UNITED STATES PATENT AND TRADEMARK OFFICE

APPLICATION NO.	FILING DATE	FIRST NAMED INVENTOR	ATTORNEY DOCKET NO.	CONFIRMATION NO.
10/696,054	10/28/2003	Allan M. Fredholm	SP02-215	5918
22928	7590	07/17/2006	EXAMINER	
CORNING INCORPORATED			LAZORCIK, JASON L	
SP-TI-3-1			ART UNIT	PAPER NUMBER
CORNING, NY 14831			1731

Office Action Summary	Application No. 10/696,054	Applicant(s) FREDHOLM, ALLAN M.	
	Examiner Jason L. Lazorcik	Art Unit 1731

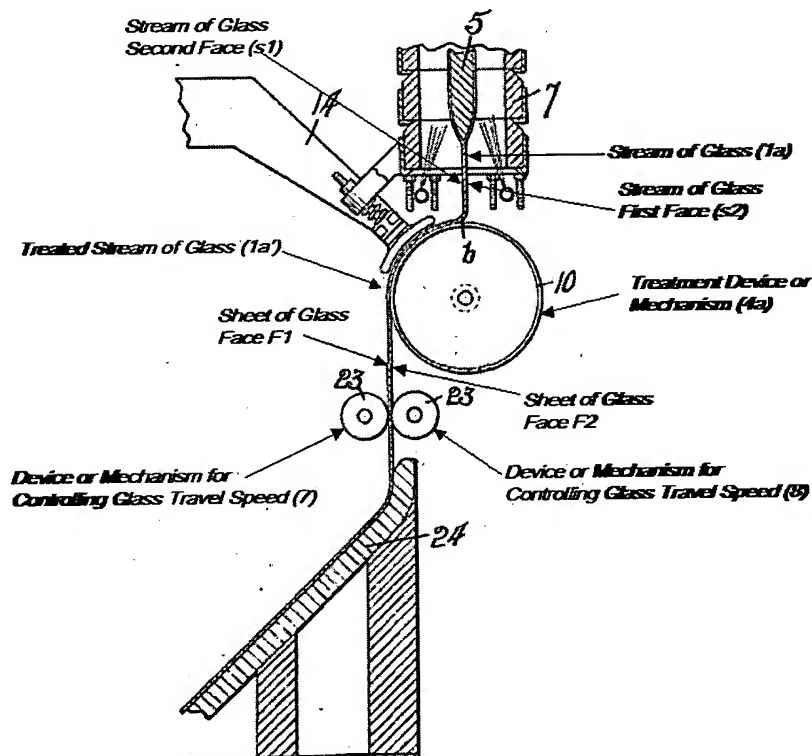
Claims 1,2, 6 through 9, and 11 through 13 are rejected under 35 U.S.C. 102(b) as being anticipated by Danner (1,674,856). The particular elements of Danner that apply to the immediate claims are set forth with particular reference to the composite excerpt from Danner Figures 4 and 5 as presented below and as labeled in accord with the applicants terminology.

1. The sheet of glass has two faces, face (F1) and face (F2) wherein one side of said sheet (F1) presents a "hardened skin surface which will prevent it becoming marred". In the context of the present claim this glass sheet presenting an unmarred, "hardened surface skin" is held equivalent to a sheet of glass with at least one of said faces presenting "a high surface quality"

2. A stream of glass (1a) delivered which has a first face (s2) and a second face (s1), and each face is free from making contact with any surface as evidenced in the region of the s1 and s2 lead lines by the above figure.

3. The first face (s2) of the stream of glass is placed into contact with a treatment device or mechanism (4a) while maintaining at least a central strip of the second face (s1) of the stream of glass (1a) free from any contact with any surface. The immediate reference indicates (pg 2, Line 53-54) that the sheet is deflected by the roll or "treatment device or mechanism (4a)" and passes around and down one side thereof which is understood as equivalent to the claimed process of supporting the weight of said glass and accompanying the falling movement of said glass.

Regarding Claim 2, the "treatment device or mechanism (4a)" aligns the treated stream of glass (1a') with and guides the treated stream of glass (1a') towards the device or mechanism for controlling the glass travel speed (7,8). As evidenced in the figure, said alignment and said guidance are provided while at least the central strip of the second face (s1) of the treated stream of glass (1a') is kept free from contact with any surface.

With respect to Claim 8, the immediate reference indicates (pg 2, lines 122-125) that the roll 10 or “treatment device or mechanism (4a)” “may be driven in any suitable or convenient manner at a peripheral speed conforming to the speed of flow of the sheet b from the slab”. It is therefore understood from the above figure that

4. From the figure, it is evidenced that there exists no relative displacement of the stream (1a) relative to the surface of the “roller (4a)” and that contact between the stream and the roller is maintained over a “significant” fraction of the circumference of said “roller (4a)”

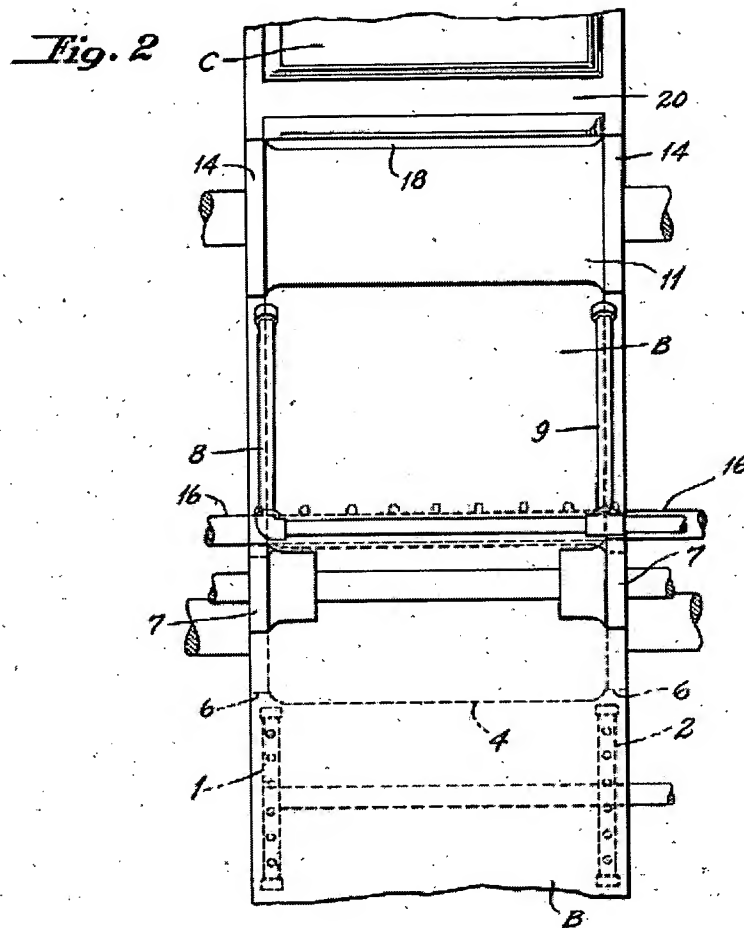
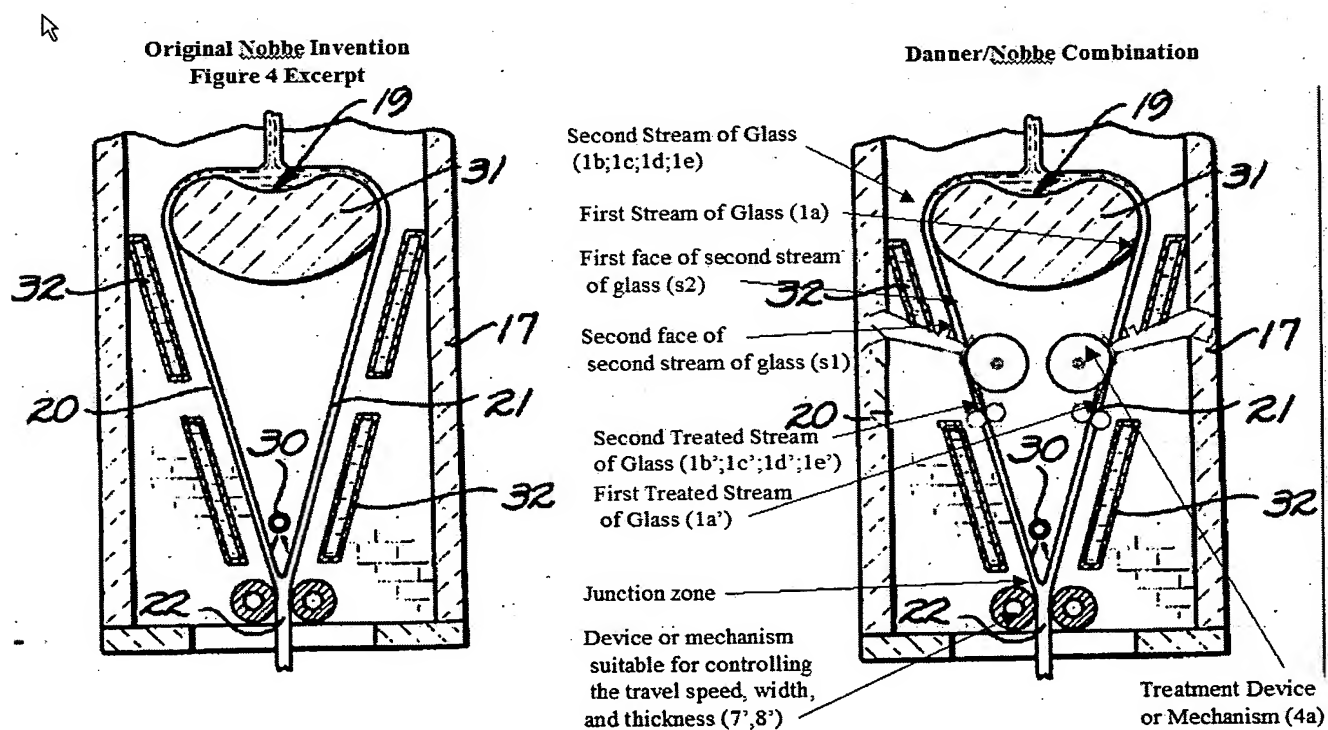
Nobbe broadly teaches of a method for the continuous production of glass sheets from molten glass wherein films of glass flow downward from a molten source while remaining substantially free from contact until being joined or laminated in a junction zone. The following two figures indicate the invention according to Nobbe Figure 4 and the obvious combination of inventions from Danner in view of Nobbe which will be described below. The combination image has been annotated for reference and clarity in the context of the presently claimed invention and will be referenced as such. It is further understood that while the combined invention as depicted applies the Danner invention both the first delivered stream of glass and second delivered stream of glass, said teachings could obviously be incorporated individually to either of the two streams and to the exclusion of the other.

1. Delivering "a second stream of glass (1b, 1c, 1d, 1e)" which by virtue of existing in the same process is understood to be compatible with the first stream of Glass (1a) . The second stream of glass (1b, 1c, 1d, 1e) has a first face and second face (s1, s2) as indicated above. Both of first and second faces of both the first delivered stream and second delivered stream are held free from contact with any surface from their formation in the region of the slab (31) and the treatment device (4a).

4. First and second treated and guided streams are joined via the first face of the of the first treated stream of glass that has come into contact upstream with said treatment device or mechanism 4a while the second face of first stream remains relatively free from contact with any surface. Further, device or mechanism (7', 8') is applied to said two joined together streams of glass.

Claim 20 is obvious in light of the objection to Claim 14 above wherein the two sheets of glass are delivered from a single source indicated by (19) in the combined figure

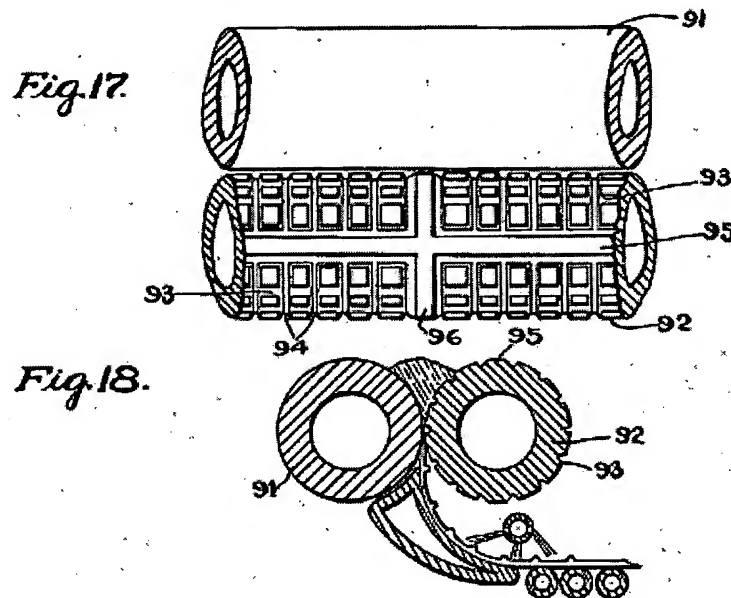
Danner-Nobbe fails to indicate that the second stream of the two streams should be treated by subjecting the second face of the second stream of glass to an action by another device or mechanism which, co-operating with the treatment device or mechanism serves to transfer an imprint onto said second face. Gelstharp teaches (see

figure 17 and 18 below) of a cooperating set of devices which serve to transfer an imprint to one side of a sheet of glass. It would be obvious to incorporate the cooperating devices as taught by Gelstharp in lieu of or in addition to the airblast nozzle (14) in treating the second sheet of glass in order to obtain a patterned surface on the exterior surface of the produced sheet of glass.
